Planning Commission Meeting Agenda
Hartland Township Hall
Thursday, June 24, 2021
7:00 PM

Hartland Township Planning Commission Meeting Agenda Memorandum

Subject: Site Plan/PD Application #21-005 Redwood Living Planned Development (PD) – Preliminary Site Plan

C203

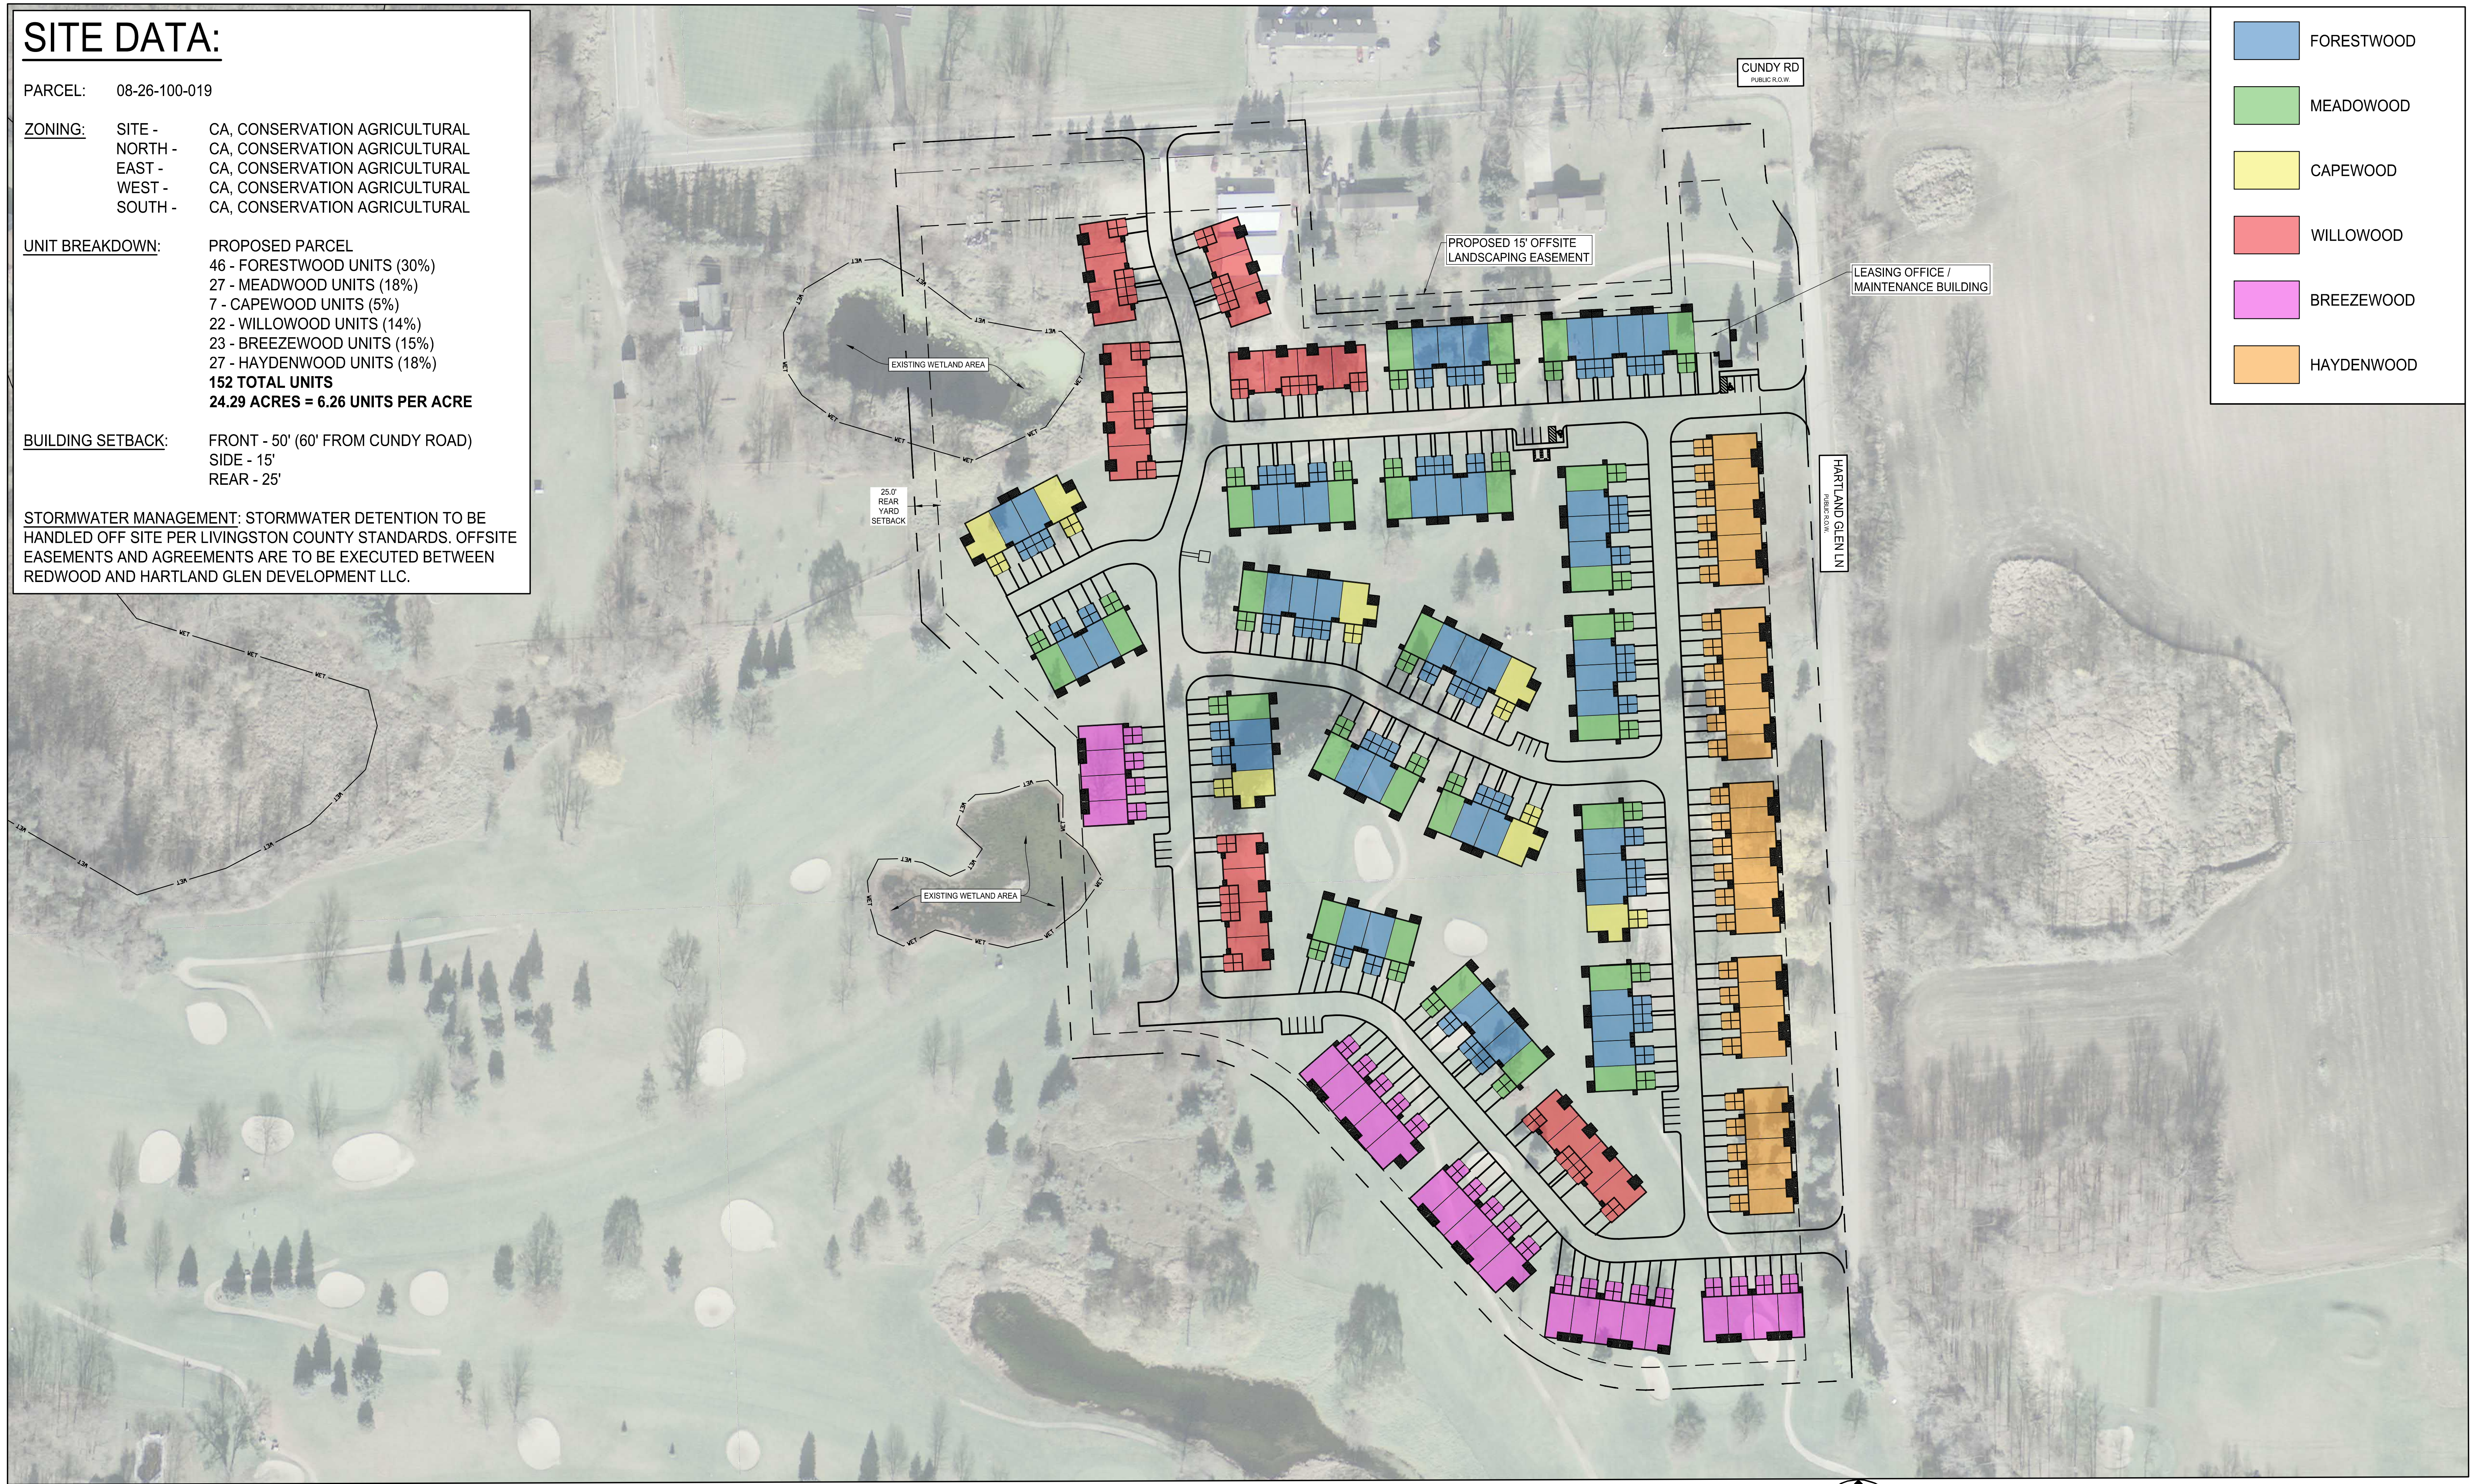
Sheet C200 lists the proposed setbacks for the project area are as follows: front (50 feet); side (15 feet) and rear (25 feet), and setback lines for side and rear are shown on the plans. The front setback line is not shown. Staff is unsure how the applicant arrived at those setback designations or locations for the setback lines. Clarification may be required.

Sheet #
L1.3

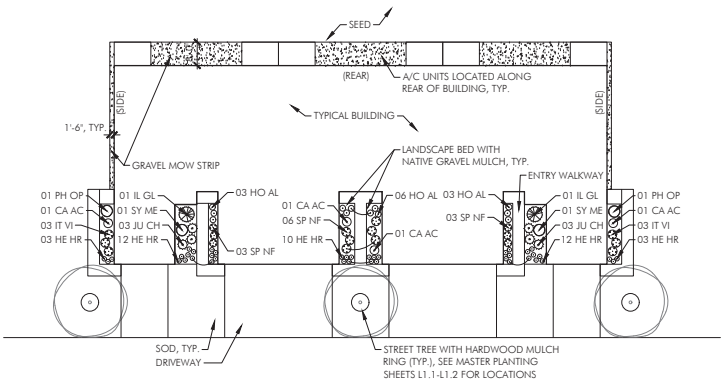
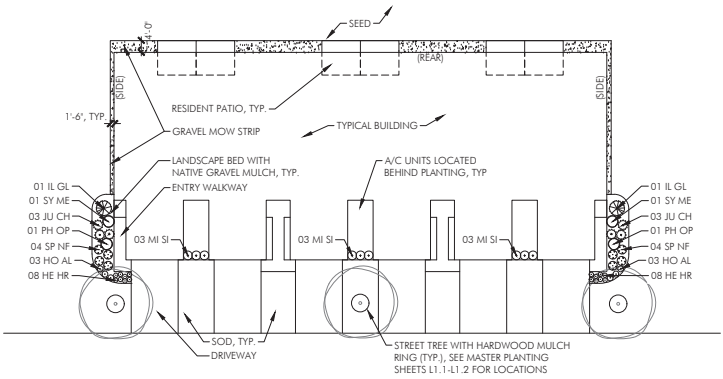
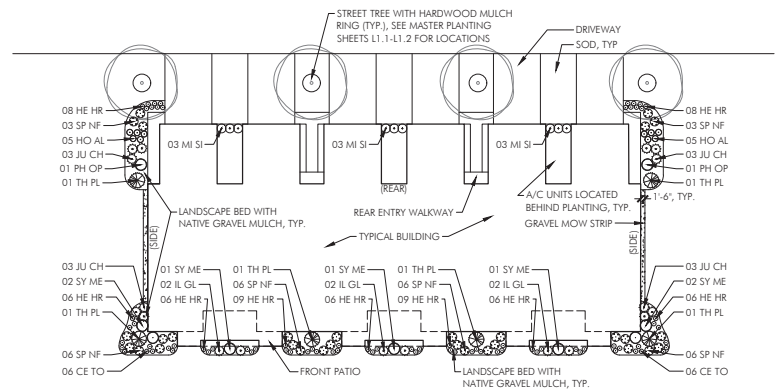
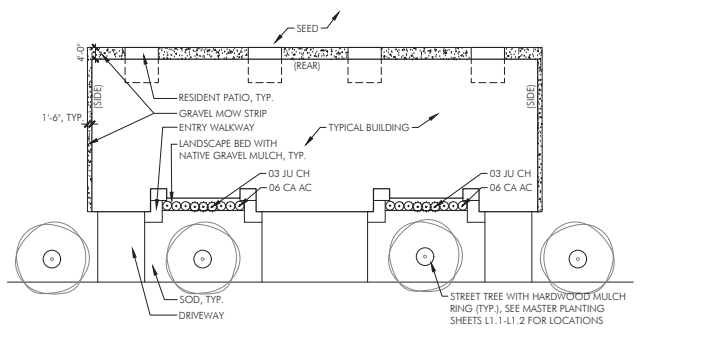
Section 5.11 does not provide landscape standards for apartment buildings. Foundation planting plans for each building model are provided in the plan set on Sheet L1.4 (Typical Foundation Planting). All planted areas will be maintained by Redwood. Irrigation is provided for all front lawns and a minimum of ten (10) feet surrounding the sides and rear of each building. Planting plans for the entrance sign, leasing office, and pavilion are shown on Sheet L1.3.
